SAFETY EVALUATION BY THE
OFFICE OF NUCLEAR REACTOR REGULATION
RELATED TO AMENDMENT NO. 17
TO LICENSE NPF-9
DUKE POWER COMPANY

PART A: Dilution of Boron Concentration in the
Boron Injection Tank

PART B: Containment Upper Compartment Temperature

SAFETY EVALUATION REPORTCONTAINMENT UPPER COMPARTMENT TEMPERATUREMcGUIRE STATION UNIT 1BACKGROUND

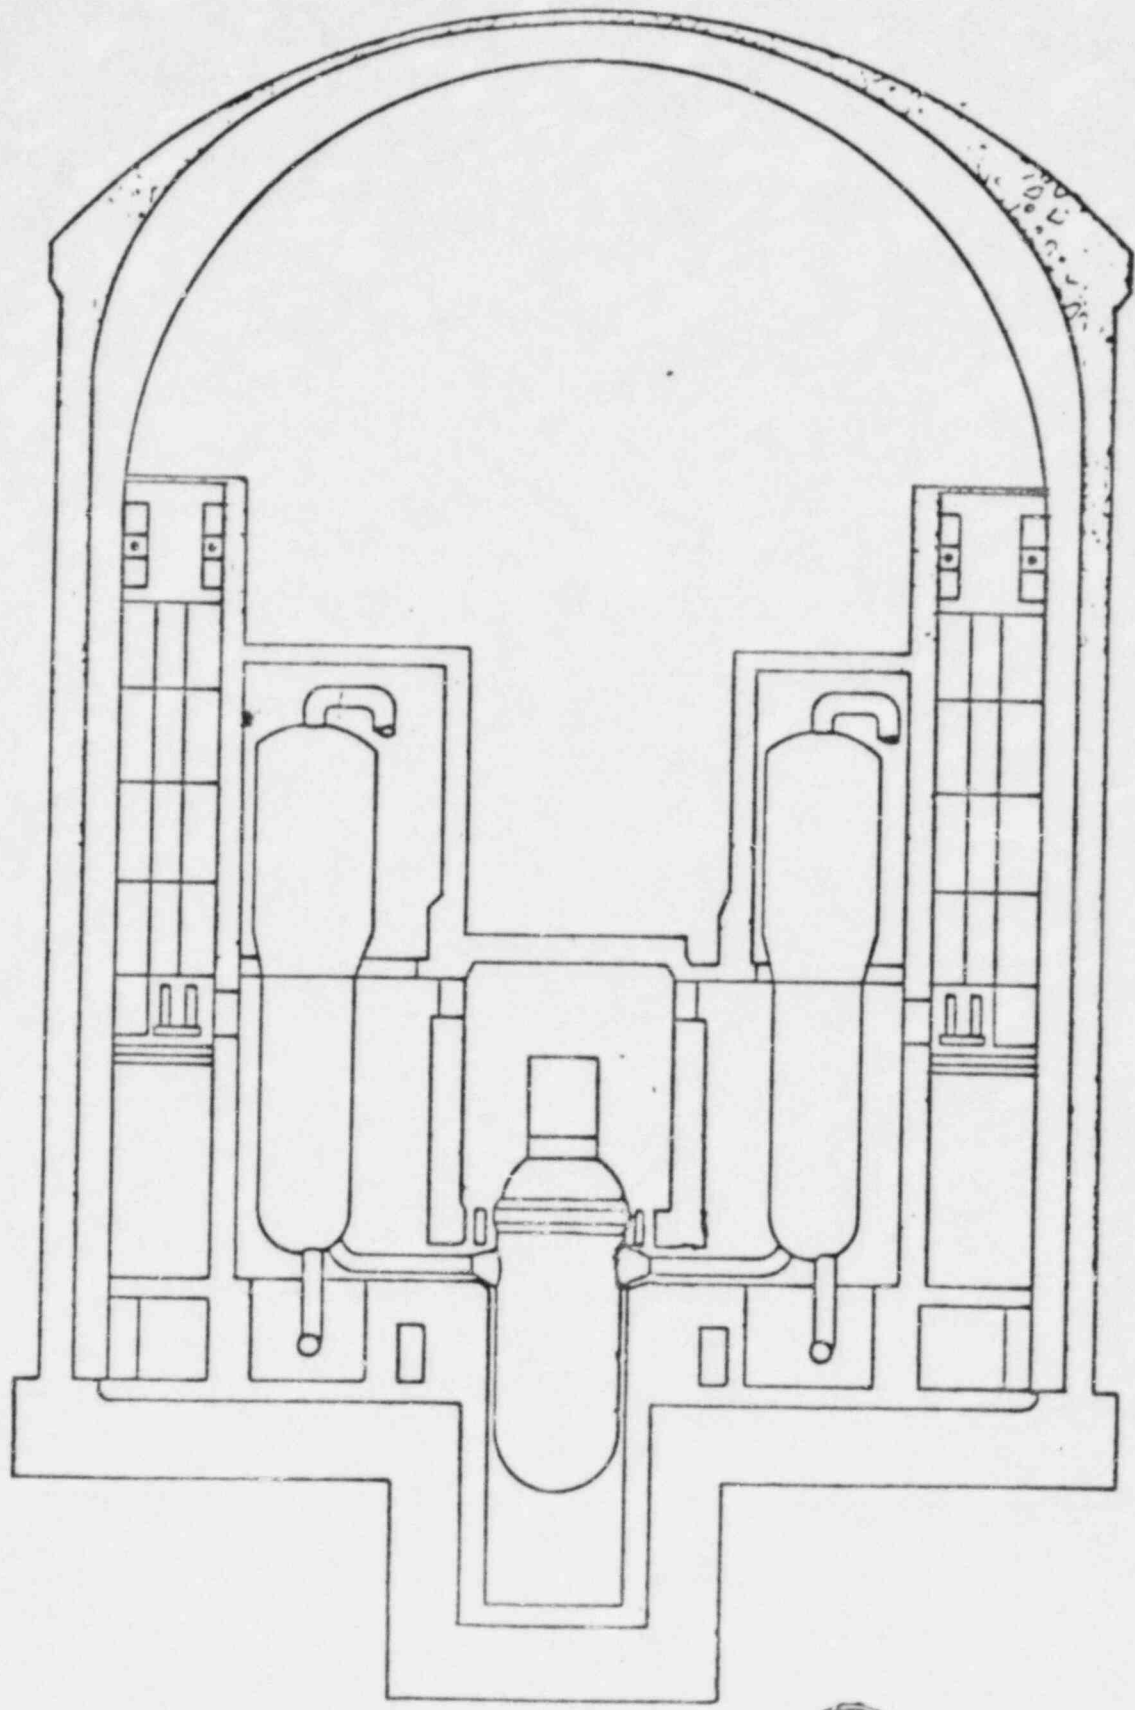
The McGuire Nuclear Station utilizes an ice condenser as a pressure mitigating system in containment. As shown on the attached figure the McGuire containment is physically divided into an upper and lower compartment. The barrier is designed to prevent steam from bypassing the ice condenser in the event of a postulated pipe rupture. Thus steam emanating from either a loss of coolant accident or a main steam line break inside containment will be forced to flow through the ice baskets which are located along the containment's perimeter. Since the steam resulting from a pipe break is largely condensed in the ice condenser, the containment internal design pressure is only 15 psig.

Due to the ice condenser system the McGuire containment is only designed to 15.0 psig. The peak calculated containment pressure is 14.8 psig. This calculation was performed using the Westinghouse LOTIC-3 computer code which has been reviewed and found to be acceptable by the staff.

As stated previously the initial mass of air in containment can have a significant affect on the peak pressure transient calculation. This is particularly true for small containments incorporating low design pressures. By placing a technical specification limit on the minimum operating temperature, the initial mass of air present in containment is limited. If a large pipe break is postulated inside containment, the containment pressure is increased by both the partial pressure of steam and the partial pressure of air as it is heated and expands.

Since the limiting containment pressure calculations found in the McGuire FSAR consistently assume 75°F as the minimum upper compartment temperature, there is no loss of margin between the proposed technical specification and that found acceptable in the staff's Safety Evaluation Report. The current value of 85°F found in the McGuire Technical Specifications is unnecessarily conservative and has no apparent basis.

Based on our review of the licensee's submittal, we conclude that the proposed Technical Specification change reducing the minimum average air temperature in the primary containment upper compartment from 85°F to 75°F does not have any adverse effect on safety of plant operation or the health and safety of the public.
